Proposed Residential Development at  
Site 10, Northern Cross, Malahide Road

Quality Audit

<b>Document Ref:</b>	<b>P22-088-UQA-GEN-RP-001</b>
----------------------	-------------------------------

*Drawing:* Drawing no. BTNC-BMD-00-ZZ-DR-C-1020 (Rev. PL6)

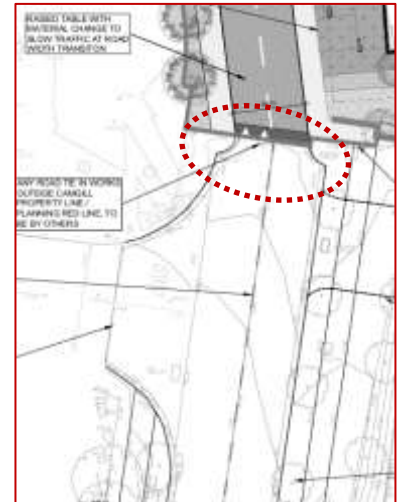
*Summary:* Sudden reduction in carriageway width at south-western entrance to proposed development.

The proposed carriageway width on the internal road is narrower than the existing carriageway width immediately south of the entrance on the south-western corner of the proposed development.

The drawings provided indicate a relatively sudden narrowing at this location, which could present a hazard to northbound vehicles entering the site resulting in a vehicle mounting the kerb and striking a pedestrian within the footpath or to sudden avoidance manoeuvres leading to low-speed head-on collisions with vehicles exiting the development at this location.

During the design development the proposed road layout at this location should be amended to remove any sudden reduction in carriageway width at this location, so that there is a smooth transition between the existing carriageway and the proposed carriageway at this tie-in.

*Drawing:* Drawing no. BTNC-BMD-00-ZZ-DR-C-1020 (Rev. PL6)

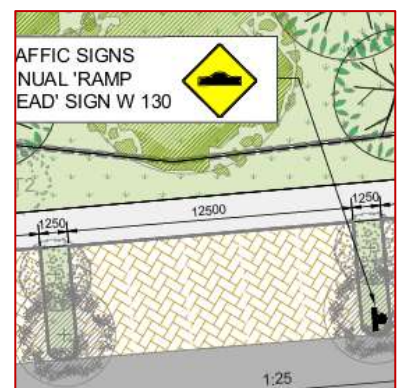
*Summary:* The proposed location of trees may reduce inter-visibility between some road users.

Trees have been indicated within the islands adjacent to some of the parking spaces and at locations of proposed road signs.

It is unclear what type of trees are proposed at these locations, but should the canopy be too low it could impede visibility for drivers exiting from parking spaces towards approaching vehicles, or obscure the sign face resulting in drivers being insufficiently aware of the upcoming road layout.

Ensure trees are located outside visibility splays or that the tree type/species selected is such that it will not impede visibility or obscure signs.

*Drawing: Drawing no. BTNC-BMD-00-ZZ-DR-C-1020 (Rev. PL6)*

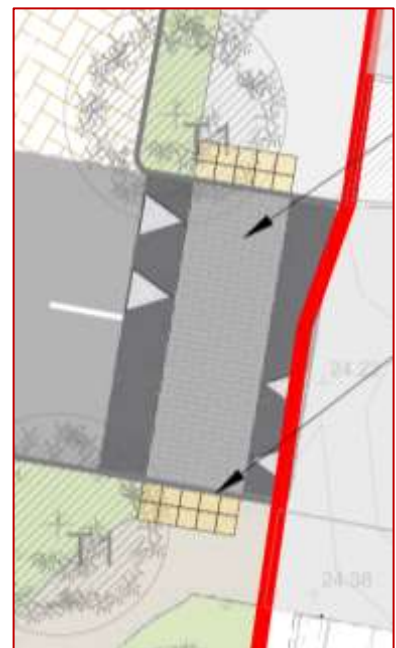
*Summary: Tactile paving at in-line uncontrolled pedestrian crossing is not of the required depth.*

An uncontrolled pedestrian crossing of the internal road at the eastern boundary is proposed, on a raised-table.

The depth of the tactile paving indicated on the approaches to this crossing are insufficient for an in-line approach, possibly resulting in a visually-impaired pedestrian inadvertently stepping over the tactile paving and failing to recognise that they are entering a carriageway/crossing.

Tactile paving with a minimum depth of 1.2m, measured parallel to the direction of an approaching pedestrian, should be provided either side of the crossing.

*Drawing: Drawing no. BTNC-BMD-00-ZZ-DR-C-1020 (Rev. PL6)*

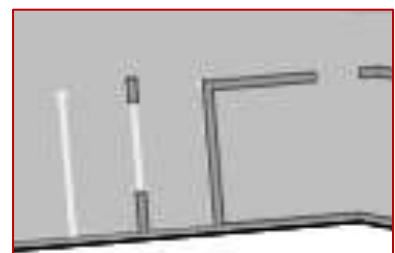
*Summary: Intervisibility between drivers exiting the basement carpark ramp and pedestrians crossing the carpark access may be restricted by the boundary wall leading to an increased risk of vehicle-pedestrian collisions.*

An uncontrolled pedestrian crossing has been indicated across the access/egress to/from the basement carpark. It is unclear if there would be adequate inter-visibility between a driver exiting from the underground car park and a pedestrian approaching from the west towards the uncontrolled crossing of the car park access ramp.

Should there be insufficient inter-visibility, this could result in an exiting driver being unaware of a pedestrian about to commence a crossing, leading to possible vehicular/pedestrian collisions.

Adequate inter-visibility should be provided between drivers of vehicles exiting the underground car park and pedestrians approaching the uncontrolled pedestrian crossing of the car park exit ramp.
